1.1 Planning Application PLN20/0447 for Construction of a part six-storey, part seven-storey residential apartment building (containing 93 Dwellings) - at Tullamore 57 Stables Circuit, Doncaster

File Number:	IN21/212
Responsible Director:	Director City Planning and Community
Applicant:	Mirvac Doncaster Pty Ltd C/- Contour Consultants Ltd
Planning Controls:	Residential Growth Zone Schedule 1 (RGZ1), Environmental Significance Overlay Schedule 5 (ESO5) and Development Plan Overlay Schedule 3 (DPO3)
Ward:	Tullamore
Attachments:	1 Locality Map 2 Decision Plans 3 Legislative Requirements

Figure 16: West Elevation (Plan Elevation TP-016)

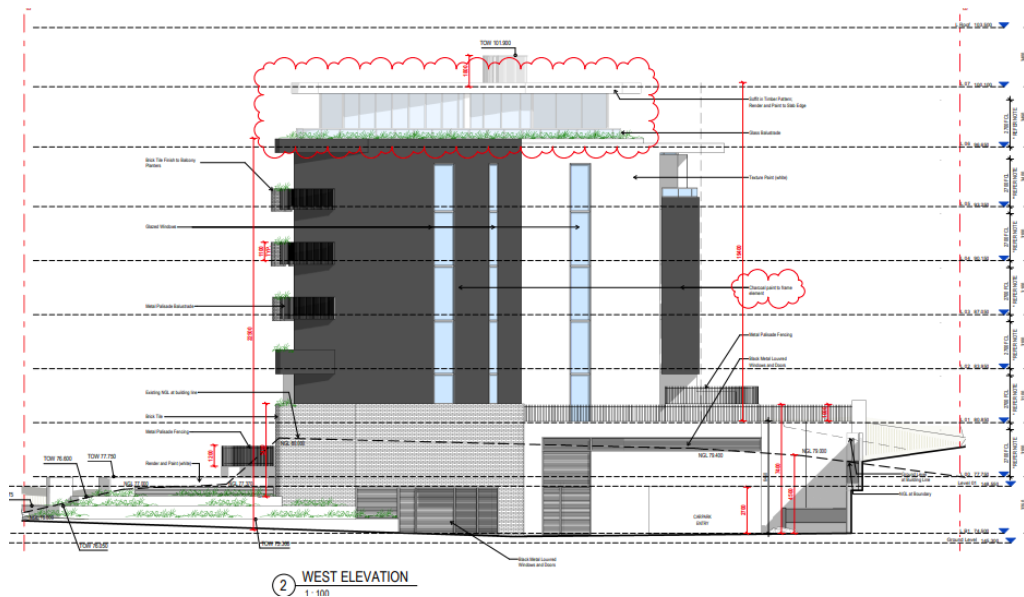
- 8.31 The design and building form however, presents five-storey sheer walls to the western and eastern elevations. As the plan elevations and Perspective views of each provided (Figures 14 to 17), both elevations offer minimal articulation and provide fenestration and material selection which exacerbates the verticality of these walls.

- Openings to the curve wall of the south-west corner balconies of Levels 2 to 4;
- Horizontal charcoal banding or similar to continue from the south-west balcony of Levels 5 and below where suitable; and
- A modified render colour or material (light grey bricks, render or textured surface) to the extent of the Level 5 western elevation, or alternative visual variation to the upper level charcoal sheer wall.
